**Response to the DPHI
2-4 Burleigh St & 20-24 Railway Parade, Burwood NSW 2134
12th of November 2025**

Attn: Joseph Puckeridge
Assistant Development Manager
NSW Housing Corporation Pty Ltd

The proposal was submitted to the NSW Department of Planning, Housing and Infrastructure (DPHI), and the Burwood Council have requested the following additional information:

Figure 1 – Proposed Porte-Cochere (Source Architectural Plan Prepared by PTI Architects)

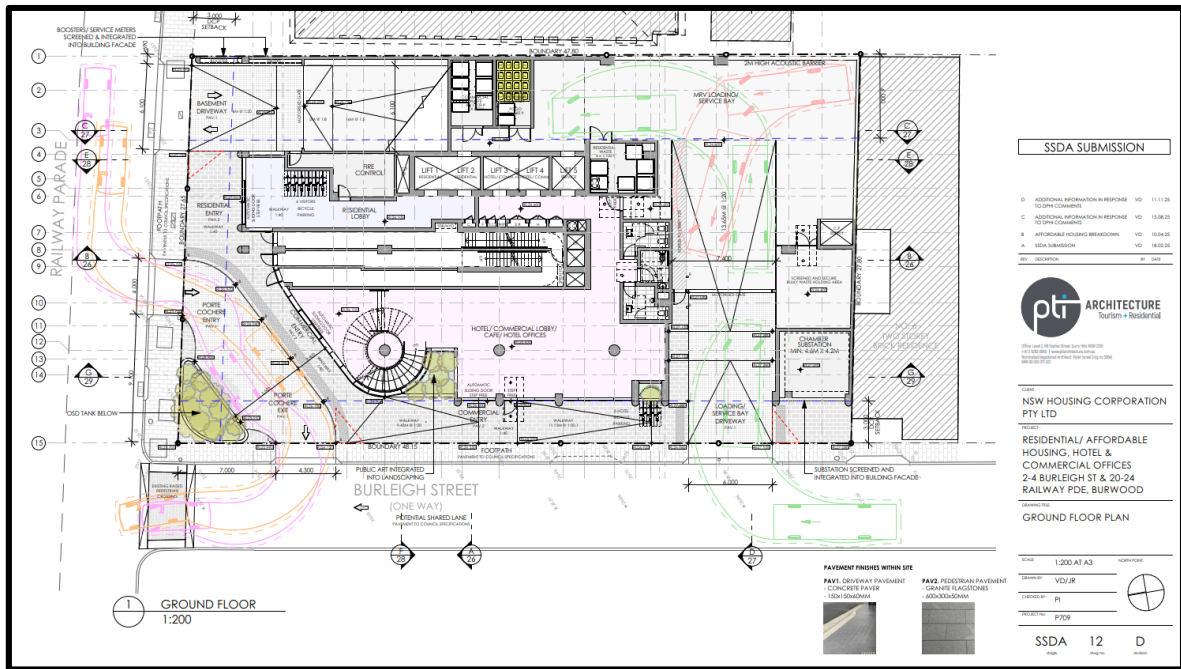
The modification to the Porte-cochere exit shows a reduced driveway width, which pushes exiting vehicles closer to Railway Parade. If the driveway is narrowed it should be required to provide a greater distance from Railway Parade to address the concerns previously raised.

The driveway servicing the Porte-cochere is now modified to include a waiting bay, as shown in the figure overleaf:

Figure 3 – Proposed Driveway servicing Basement Level (Source Architectural Plan Prepared by PTI Architects)

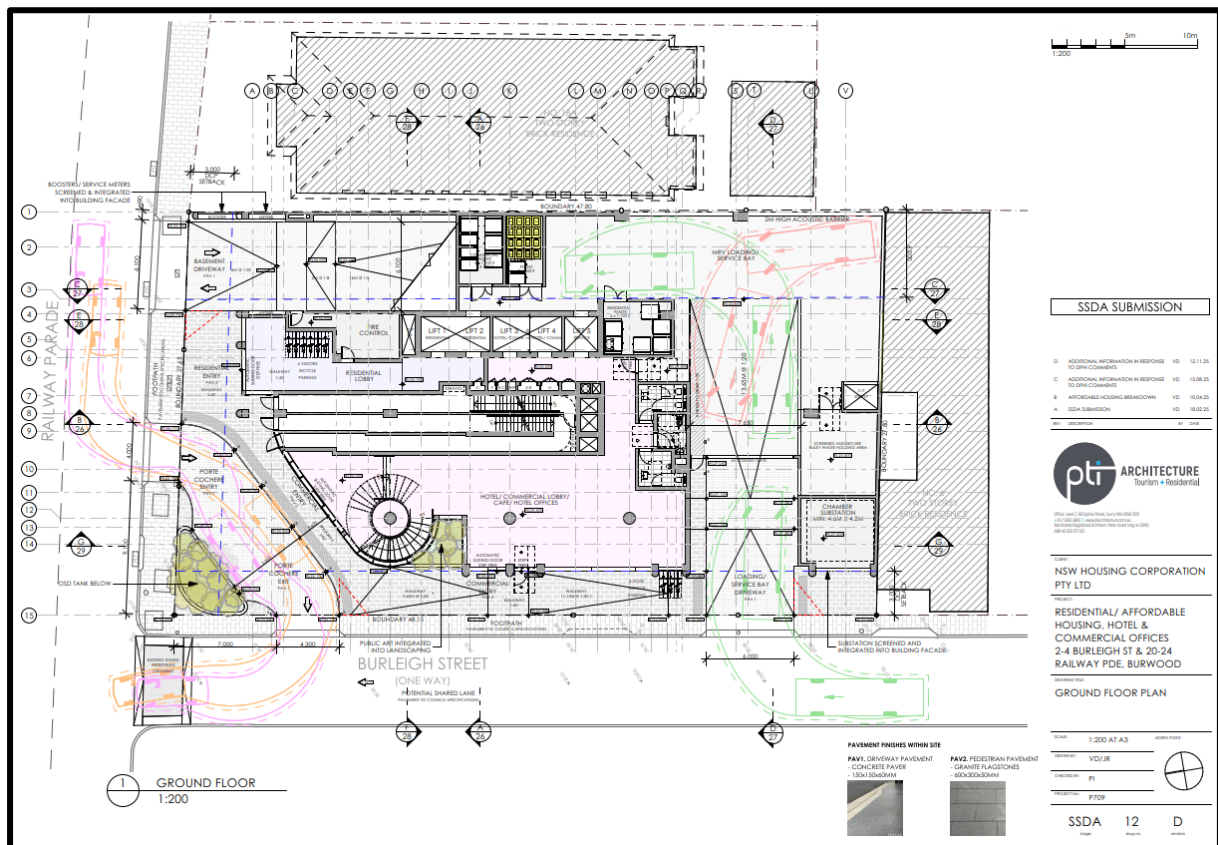
The modification to the basement driveway which now includes an offset between the vehicle crossover at the kerb and the internal aisle is not supported as it will lead to conflict between entering and exiting traffic.

The driveway serving the basement-level car park has been modified to align with the internal aisle. For additional details, please refer to the updated architectural plans (Ground floor- drawing No SSDA-12 Revision D) and an extract of the driveway is presented in the figure below:

Figure 4 – Swept Path Assessment Demonstrating B85th vehicle type accessing the Porte-Cochere

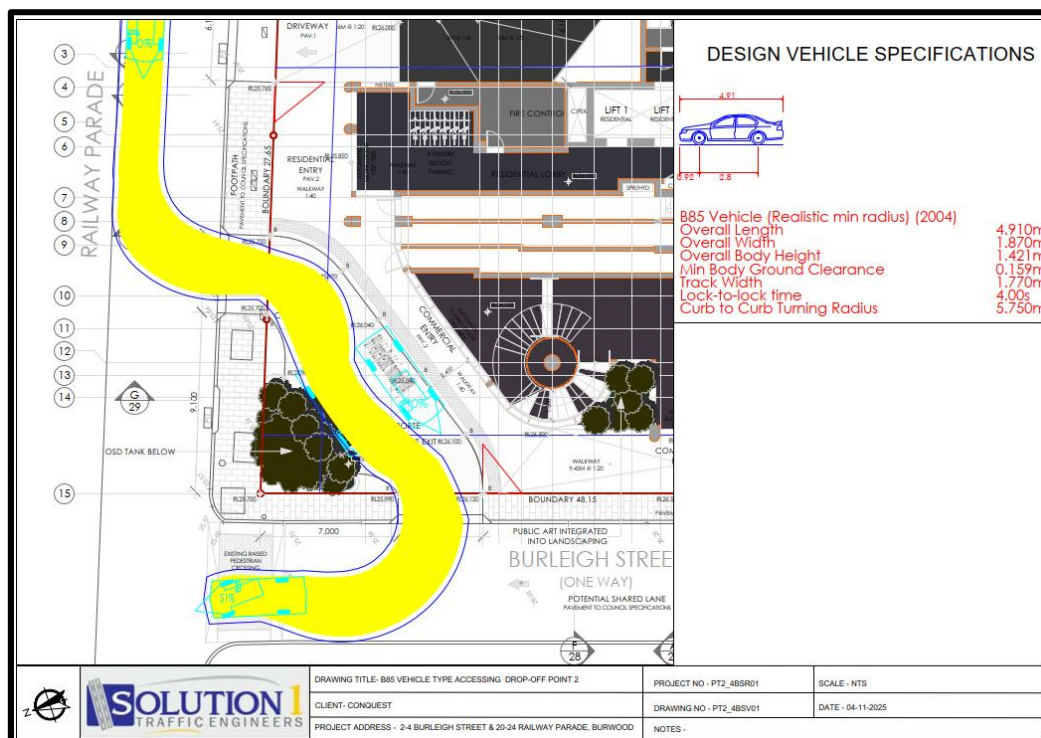
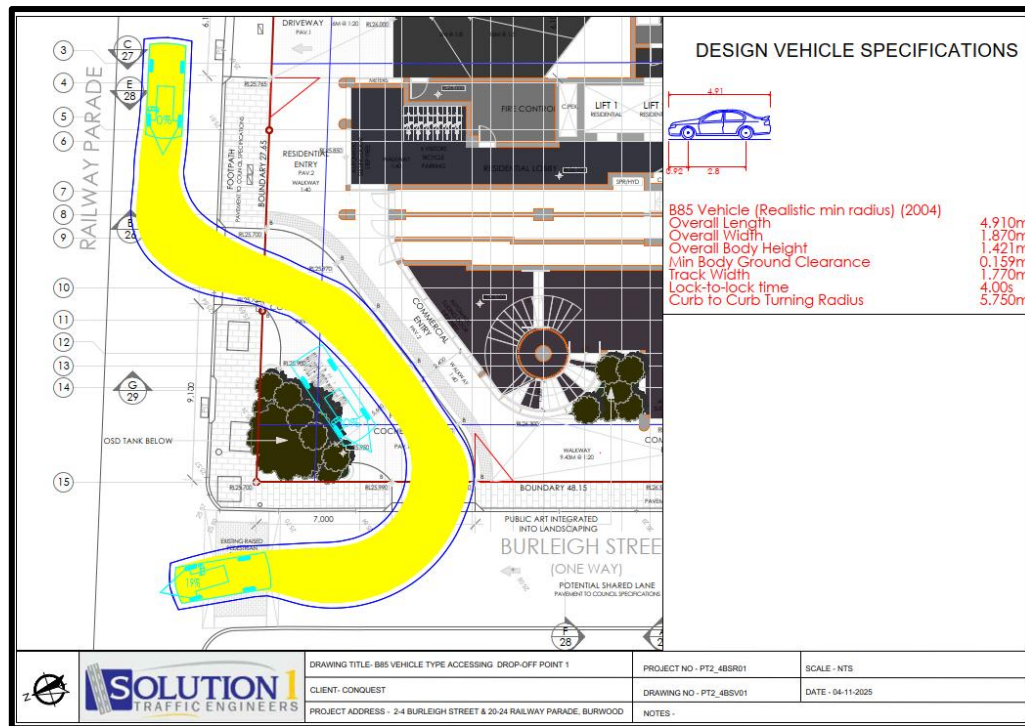
No evidence in the way of swept path analysis has been provided for the design of the Porte Cochere to show how two vehicles can use this space simultaneously, or how one vehicle entering can enter if another vehicle is already parked in this space.

Swept path diagrams have been prepared to check the proposed Porte-cochere access arrangement. Swept path was undertaken using Autodesk Vehicle Tracking software with the application of Standard B85th & B99th passenger vehicles. The swept paths are shown below, and it is concluded

that the proposed design is adequate to allow for a passenger vehicle to enter and exit in a forward direction.

Figure 5 – Proposed Porte-Cochere(Source Architectural Plan Prepared by PTI Architects)

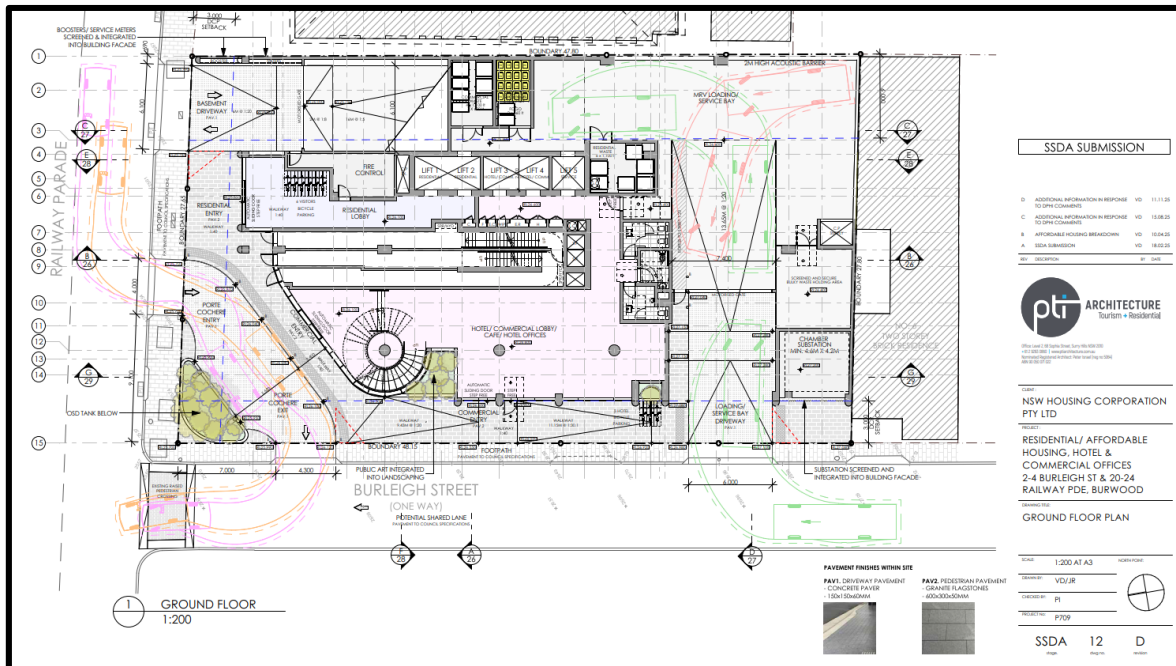
An adjoining breakdown lane strip 2.0 wide is provided on one side of a single queuing lane. Ref AS 2800.1:2004 Section 3.4 Table 3.3 has not been provided.

The submitted plans do not demonstrate compliance with AS: 2800:2004 and other relevant technical guidelines. Existing transport network operations and high pedestrian activity at this location require this to be addressed by the Applicant.

The access driveway for the Porte cochere needs to comply with AS 2890.1:1994 and have clear sight lines to in accordance with Figure 3.1 Section 3.2.4 AS 2890,1:2004.

The driveway servicing the Porte-cochere is now modified to include a waiting bay, as shown in the figure overleaf:
